October 24, 2017
Medway Planning and Economic Development Board
155 Village Street
Medway, MA 02053

143 Village Street Special Permit and Site Plan – Public Hearing Continuation

Ref: Tetra Tech Comments: 143 Village Street Medway, MA Site Plan Review

**Re: Site Plan Review
143 Village Street
Medway, Massachusetts**

DATE SEPTEMBER 6, 2017	SCALE 1"=10'
SHEET 2 OF 7	JOB NO. F4158

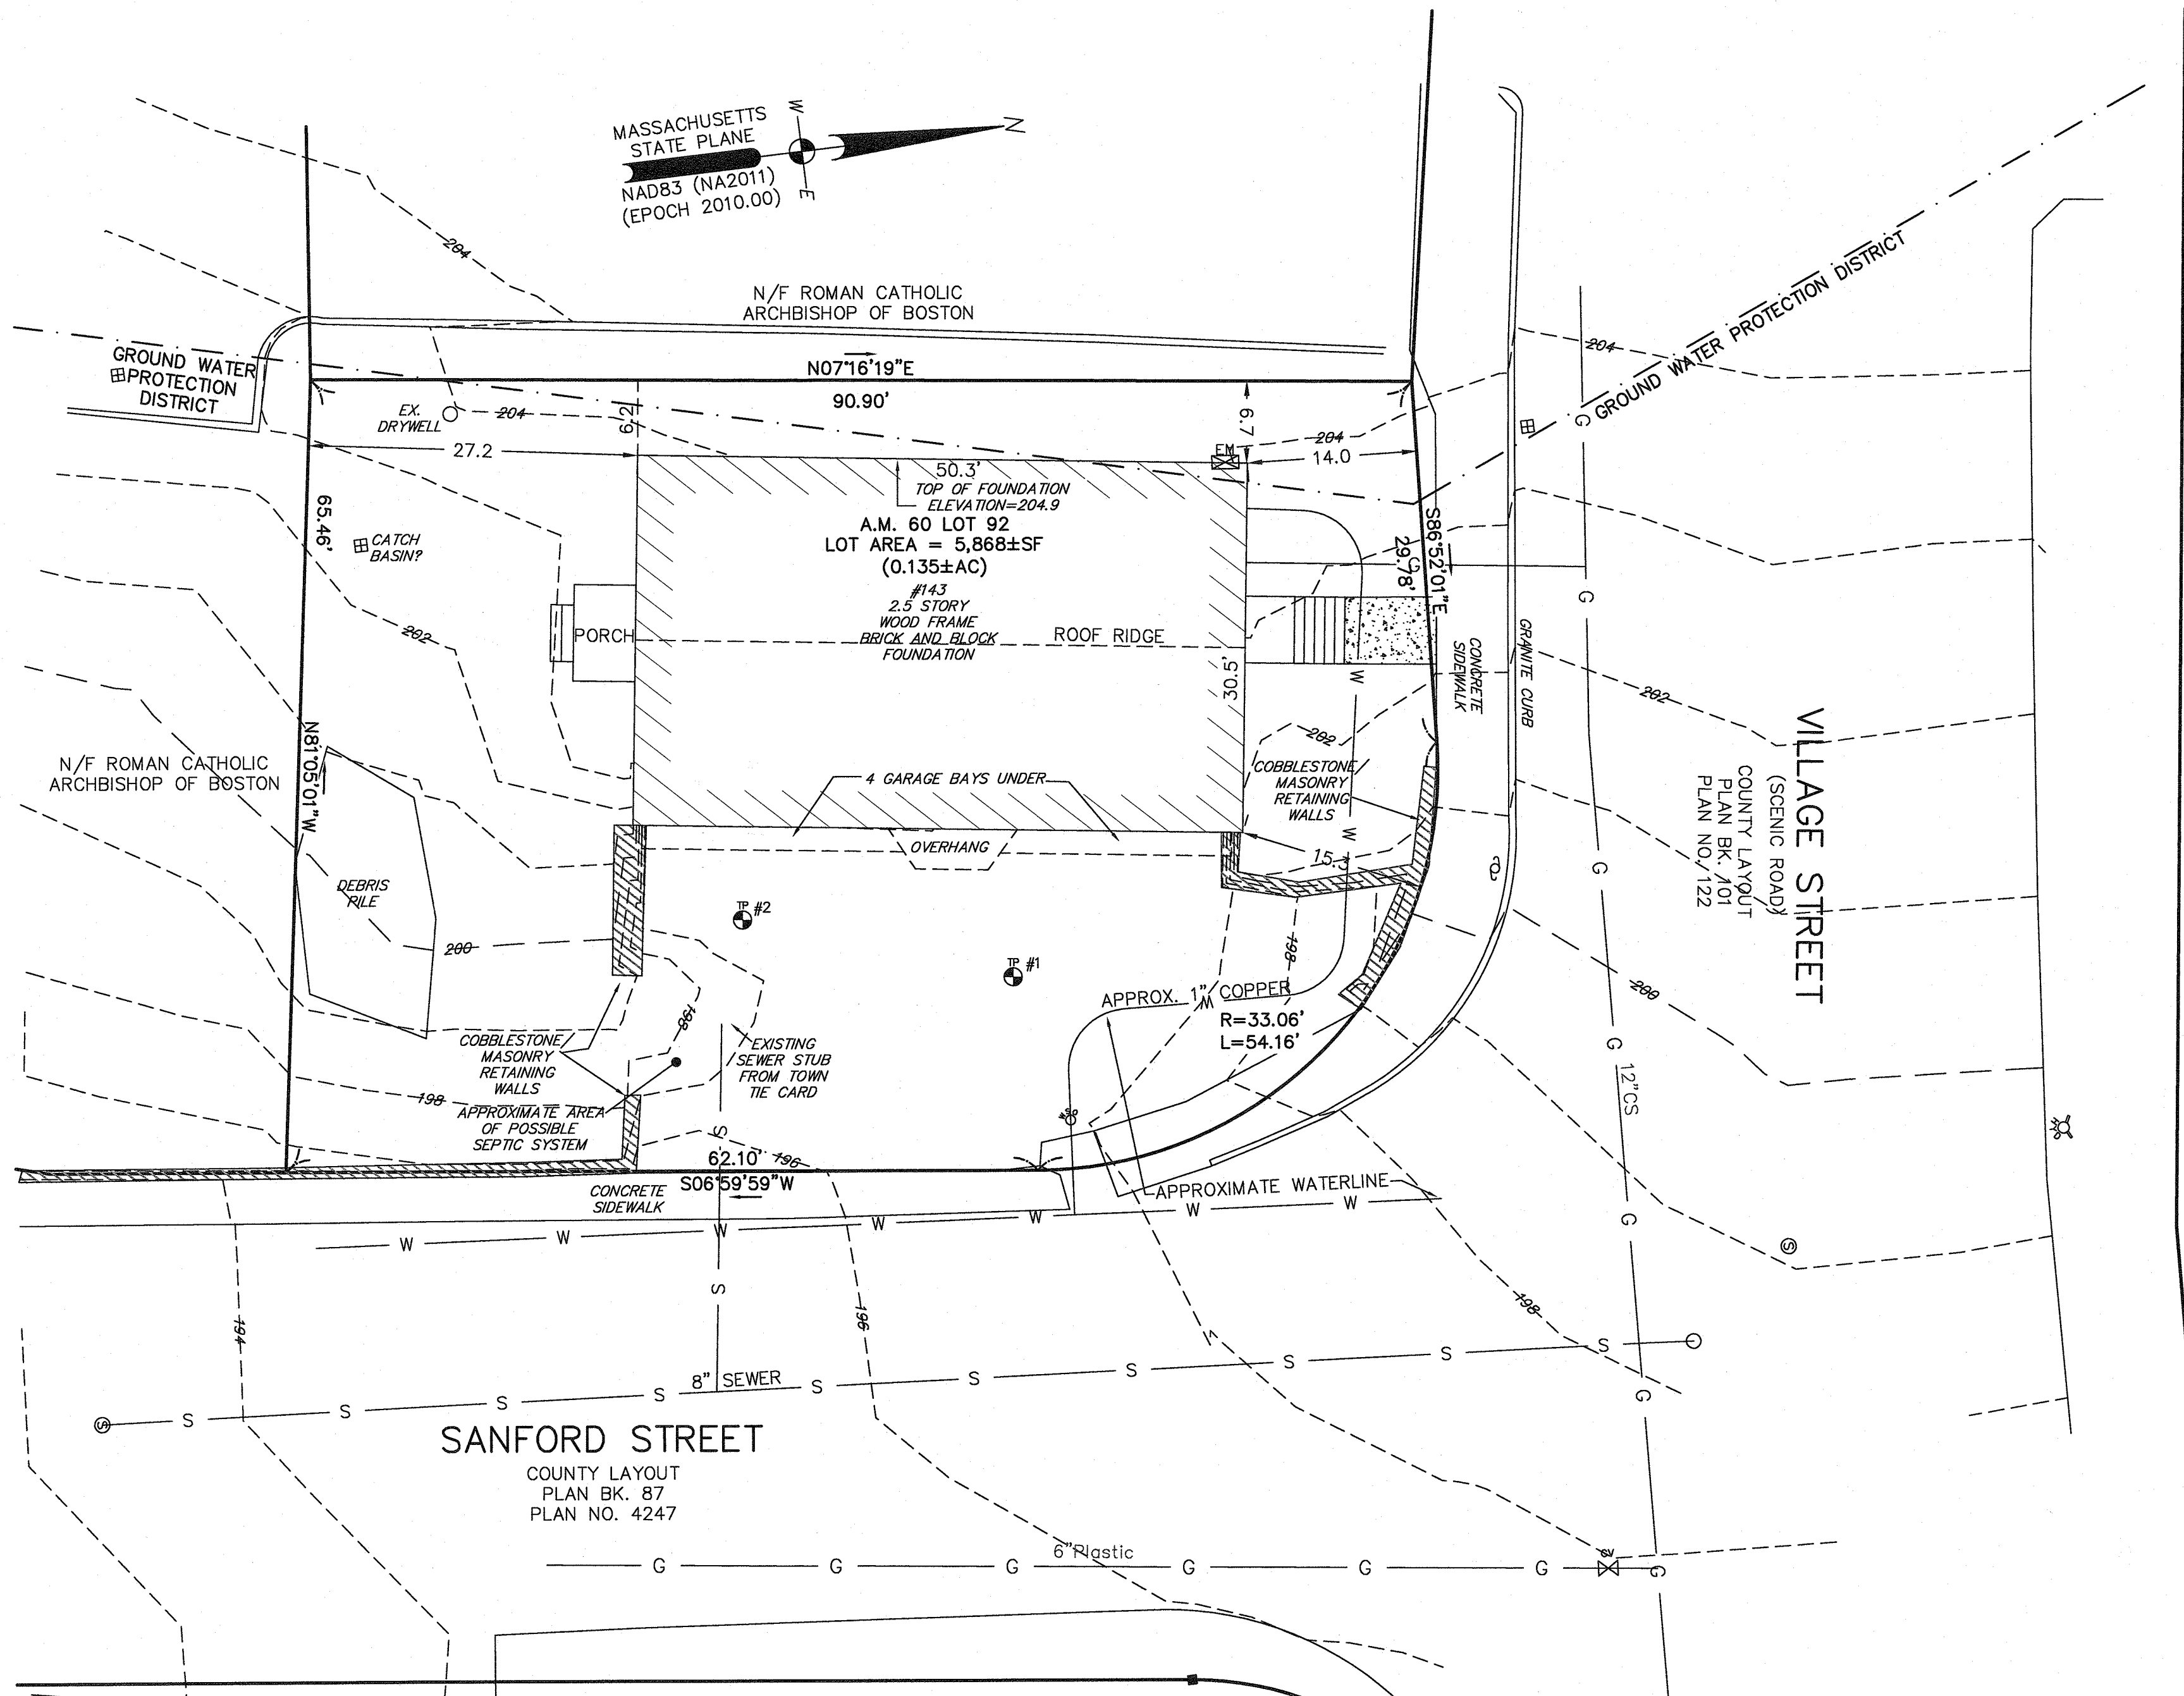
- 8) *The applicant has not provided required building setback lines on the Plans. (Ch. 200 §204-5.D.1)*

- **Revised as requested. The building on the site is existing and setbacks to the boundary are shown. See plan entitled “Existing Conditions” Sheet 2 of 7**

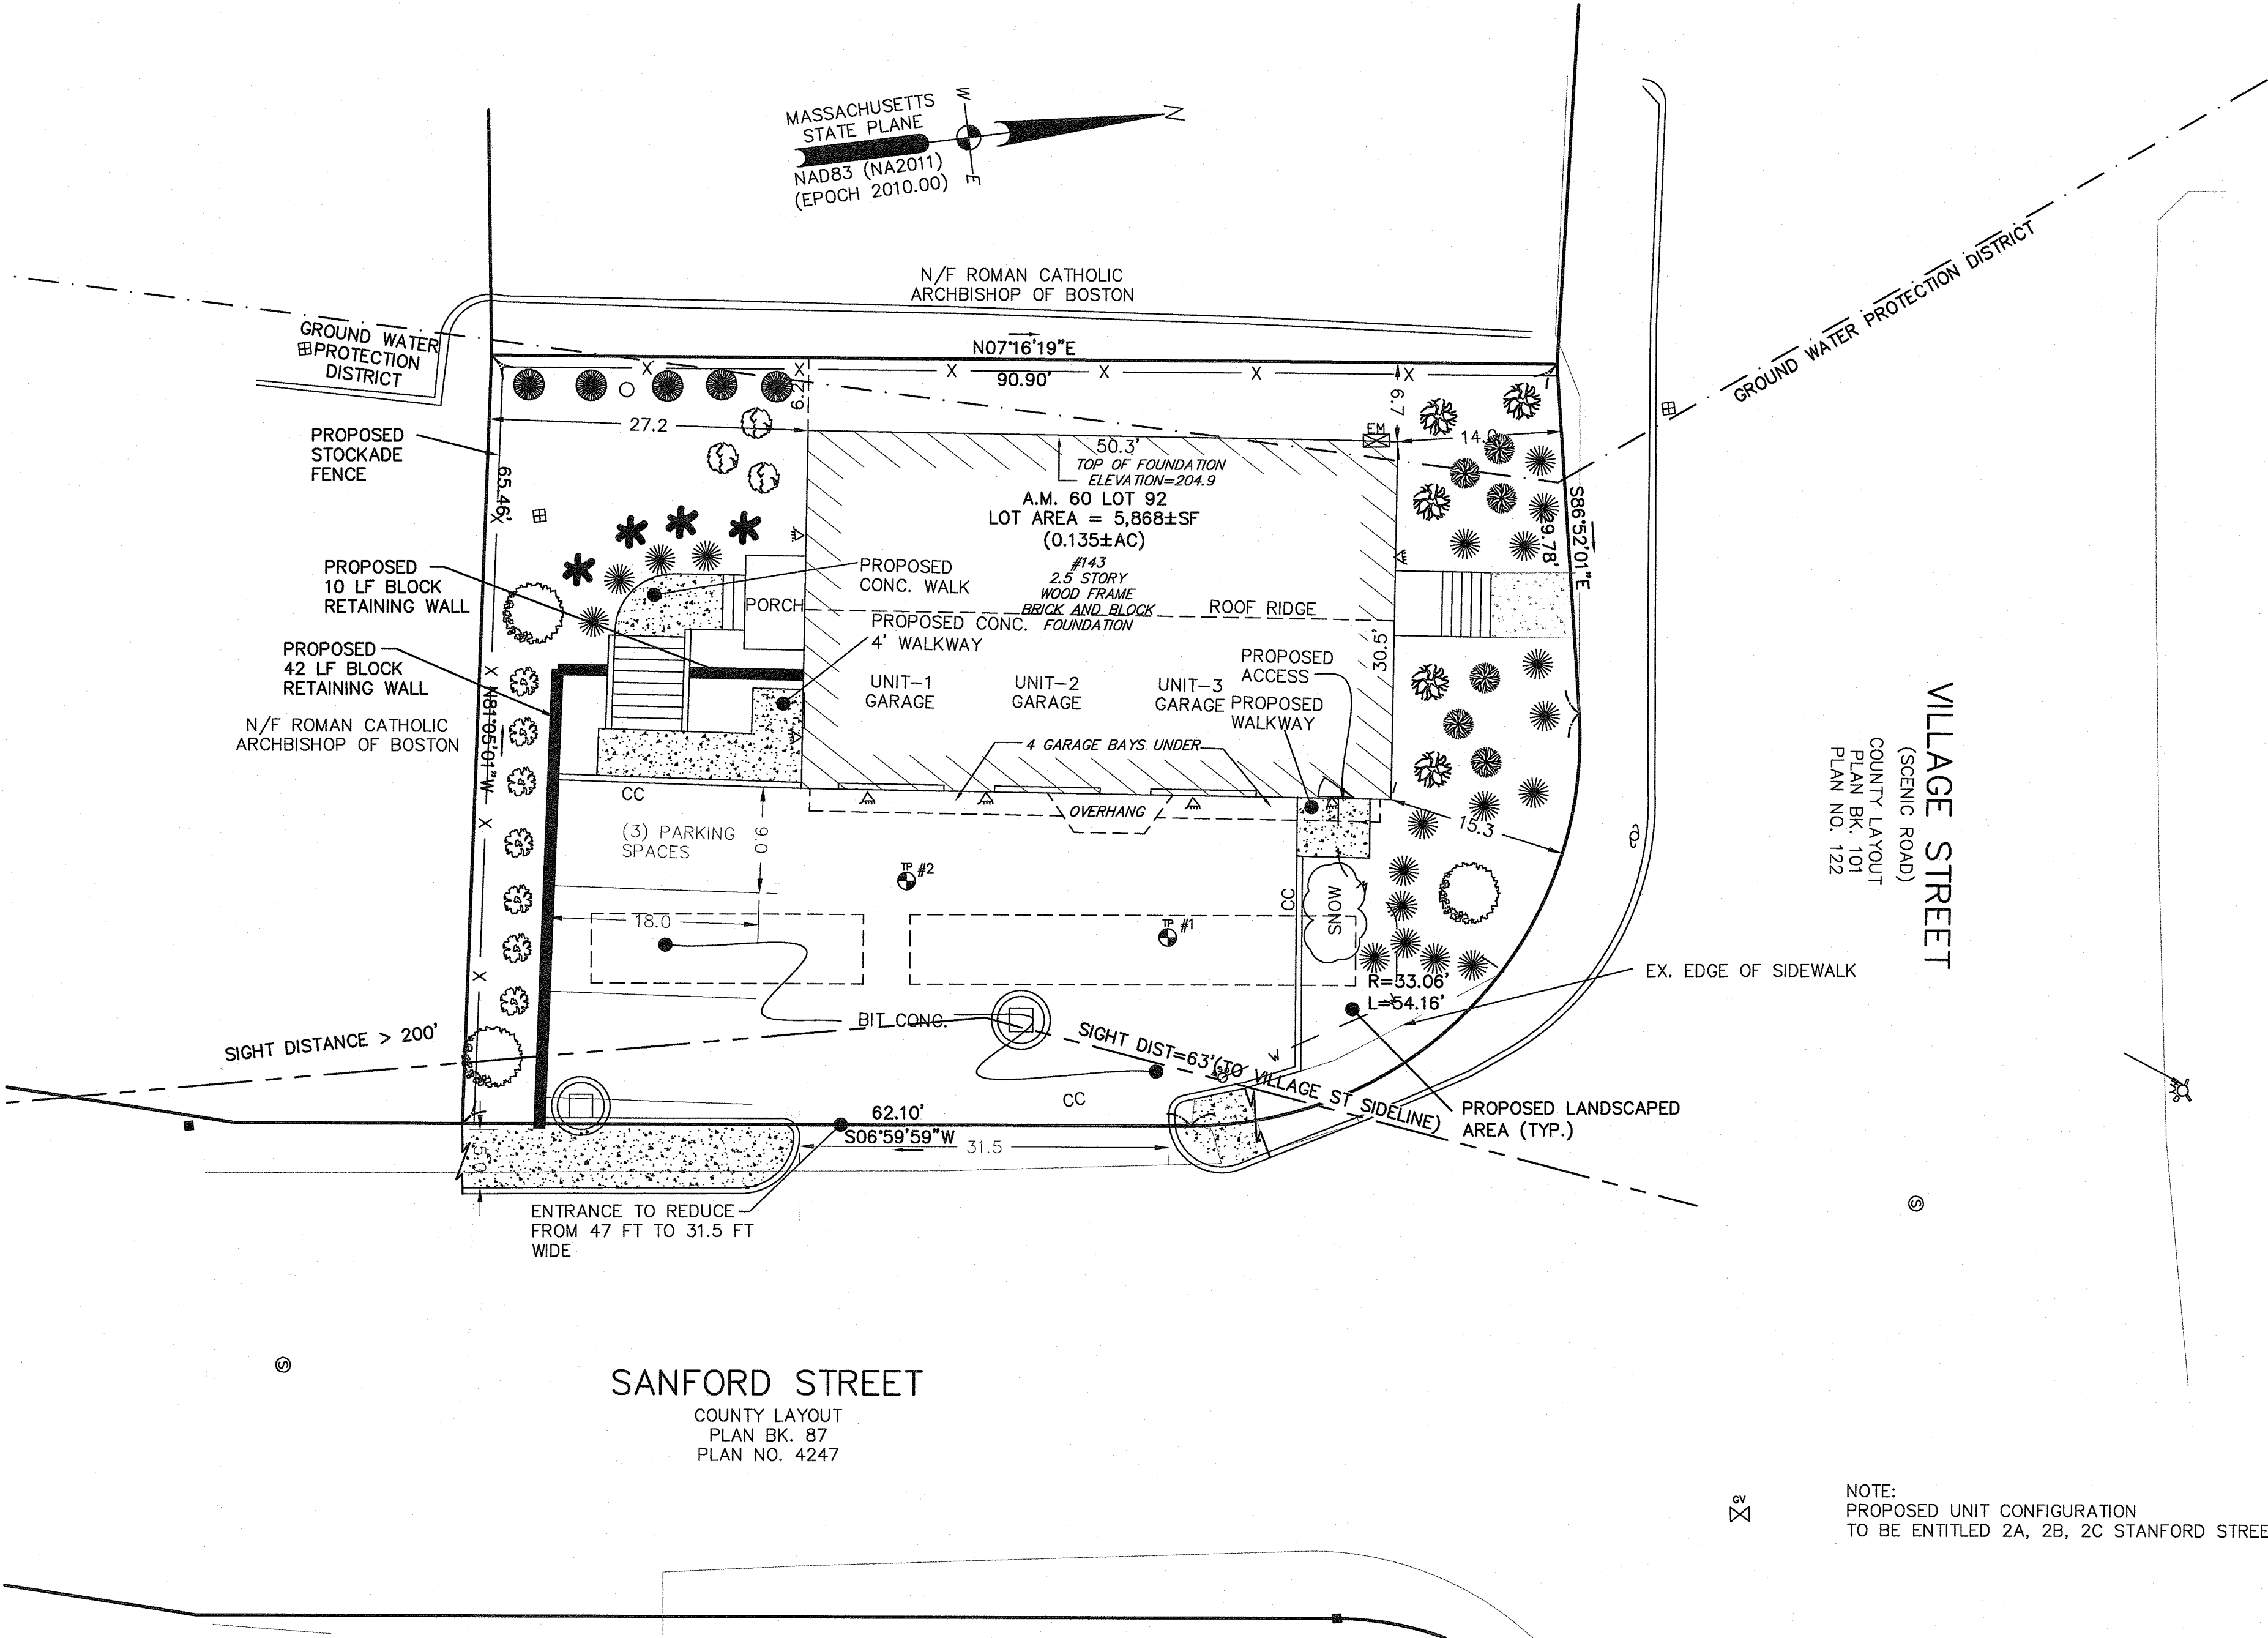
- 9) *The applicant has not provided required parking setback lines on the Plans. (Ch. 200 §204-5.D.2)*

- 20) *The applicant has not provided proposed parking space sizes on the Plans and spaces do not appear to not meet minimum criteria. (Ch. 200 §205-6.G.3)*

- TT 10/18/17 Update: This item has been addressed to our satisfaction.
- 14) The applicant has not provided horizontal sight distances at the proposed driveway. The proposed driveway is within 50 feet, and significantly downhill, of the Village/Sanford Street intersection. Its downhill position reduces reaction time and limits sight distance as vehicles make the right turn from Village Street to Sanford Street. Providing adequate sight distances is essential to maintaining safe egress from the Project driveway and travel along Sanford Street. (Ch. 200 §204-5.D.14)

- **Revised as requested. See plan entitled “Site Layout & Landscaping Plan” Sheet 3 of 7**

- **Revised as requested. See plan entitled “Site Layout & Landscaping Plan” Sheet 3 of 7**
- 21) *The applicant is providing parking in an area that will require vehicles exiting the site to back into a roadway which is not acceptable. Furthermore, it is our opinion that this location poses particular risks due to its proximity to Village Street/Sanford Street. (Ch. 200 §205-6.G.4(c))*

- *GHI 10/10/17 Response: Revised as requested. See plan entitled “Site Layout & Landscaping Plan” Sheet 3 of 7.*
 - TT 10/18/17 Update: The proposed design does not meet the regulation as the site driveway remains proposed less than 50 feet from the intersection. We recommend the applicant request waiver from this regulation.
